Subject: Docket Nos. 50-361 and 50-362
San Onofre Nuclear Generating Station
Units 2 and 3

Enclosed are sixty-three (63) copies of responses to additional NRC Equipment Qualification Branch questions concerning the seismic qualification of equipment. These responses provide additional information requested by the seismic qualification review team during telephone conversations with SCE and SCE consultants on March 19 and 25, 1981. The remaining information requested will be provided by April 17, 1981.

Response to Questions Raised by NRC in Summary of SQRT Plant Site Review

Response to Additional NRC SQRT Audit Questions

DESIGN BASIS EARTHQUAKE
VERTICAL ACCELERATION RESPONSE
SPECTRA AT NODE 1, ELEVATION 8'-0"
OF AUXILIARY BUILDING

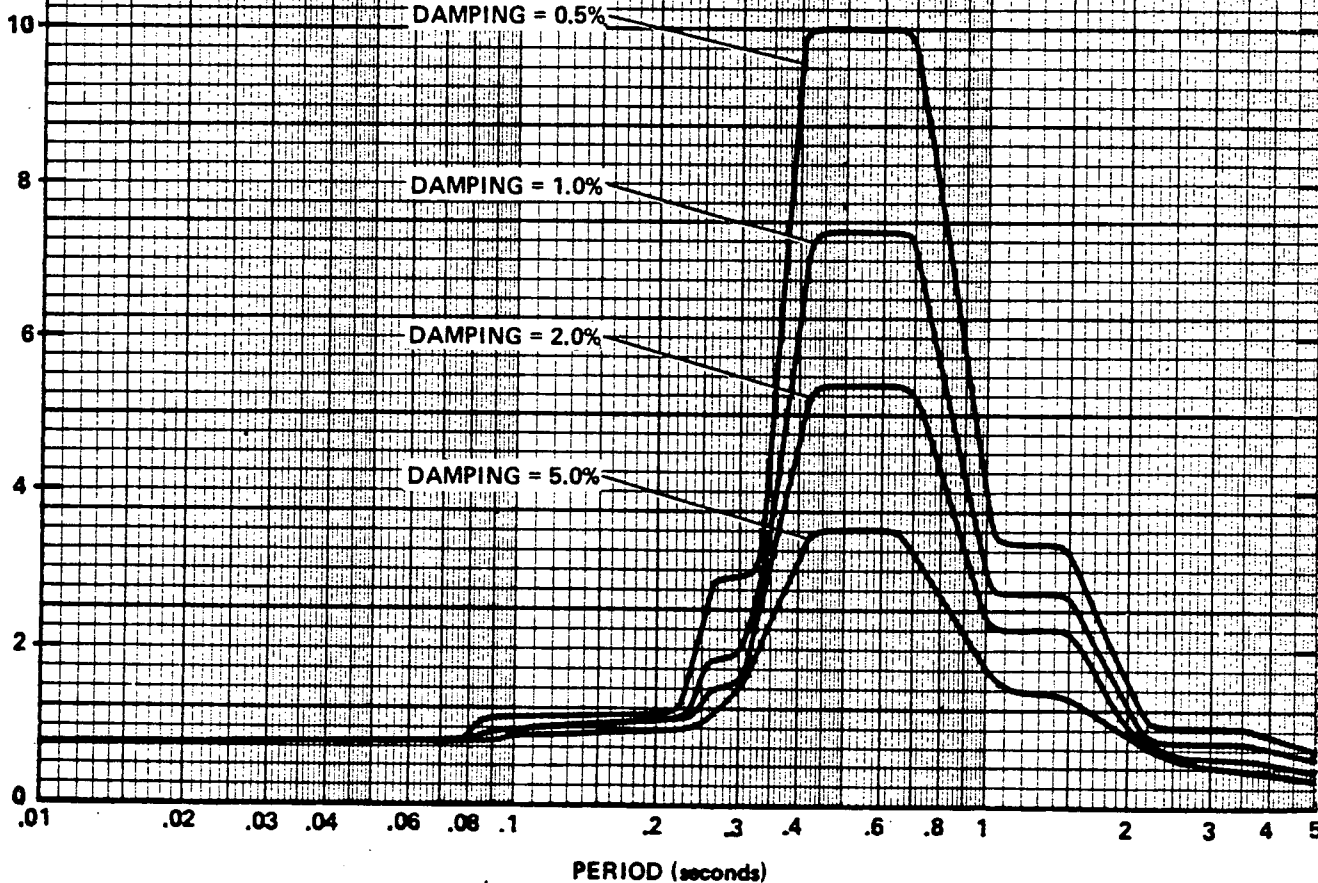
Provide seismic qualification for pulsation dampers associated with the charging system (NSSS-25).

Enclosed you will find SQRT audit forms for the charging pump suction stabilizer and discharge pulsation dampers. These components were included in the piping analysis for the purpose of determining piping stresses and nozzle loads. The seismic qualification was in accordance with our procedure for in-line piping components discussed in our response to SQRT Audit Item BOP 19. Both components were qualified by analysis in accordance with option 1a of that procedure since these components were shown to have fundamental natural frequencies greater than 33 Hz.

DESIGN BASIS EARTHQUAKE
VERTICAL ACCELERATION RESPONSE
SPECTRA AT NODE 9A, ELEVATION 50'-0"
OF CENTRAL CONTROL AREA, AUX. BLDG.

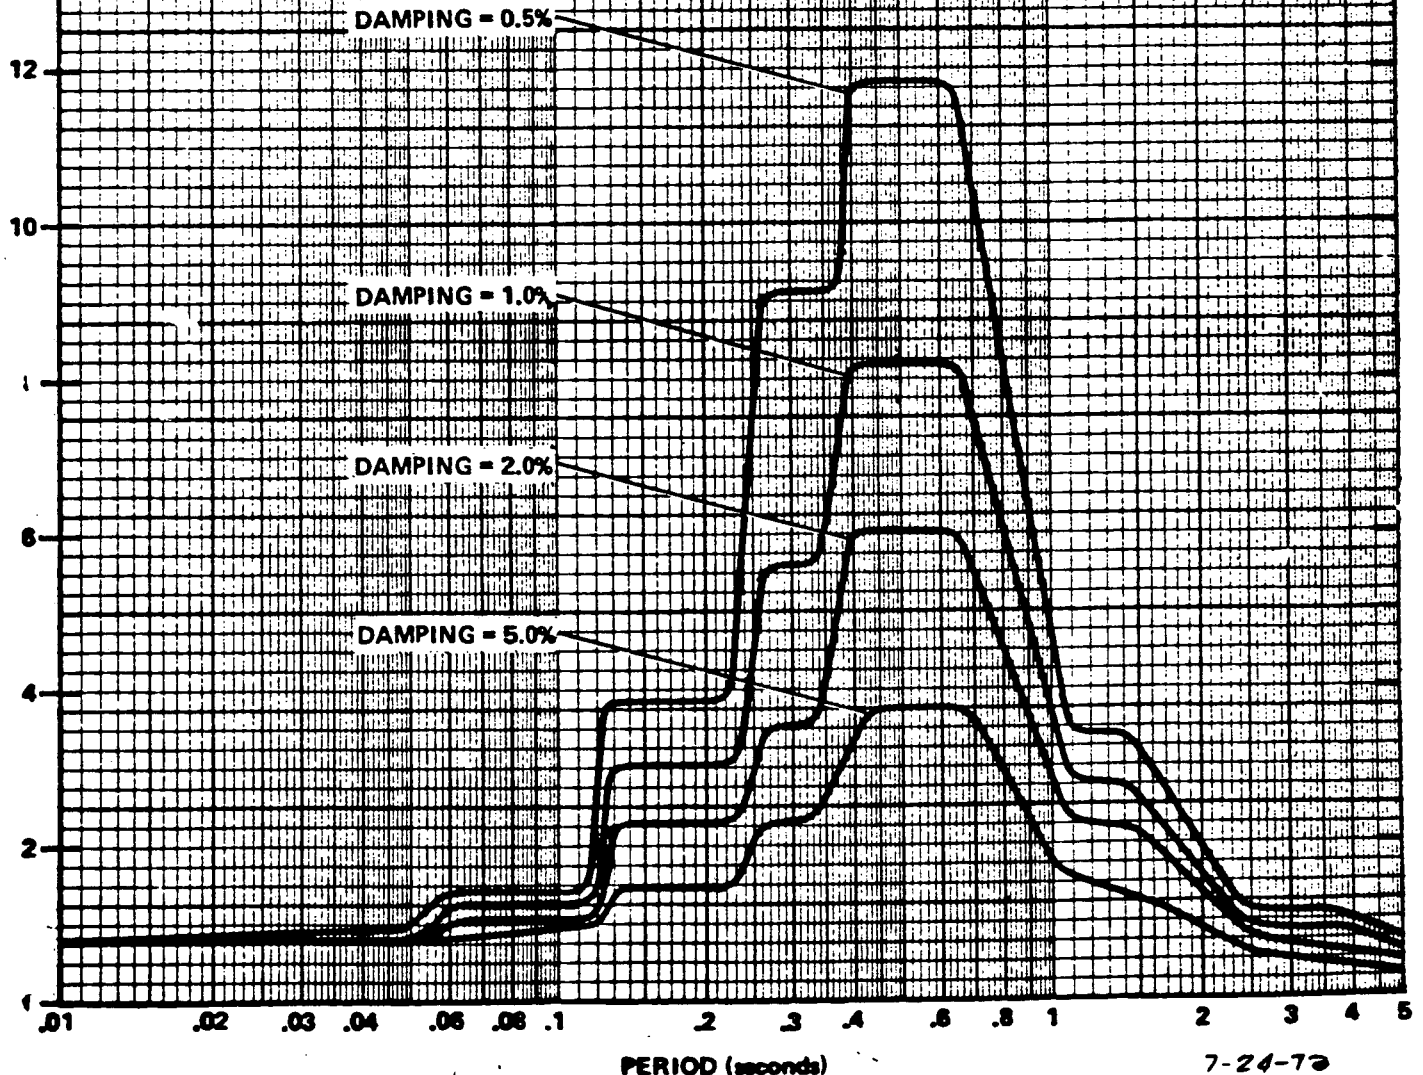
Provide seismic qualification summary forms for the following items; Station Batteries (BOP 5), Controllers (NSSS 10), Containment Purge Radiation Detectors (NSSS 21) and Containment Purge Radiation Transmitters (NSSS 22)

Attached you will find copies of the requested seismic qualification summary forms. The forms for BOP-5 are for the in-place Exide Model G batteries which have a limited qualification life (3.9 yrs). We plan on replacing these batteries with the Exide Model GN batteries once the current qualification program has been completed. The current forecast for completion of this program is July 27, 1981 with a forecast completion of the revised seismic qualification summary forms by October 2, 1981.
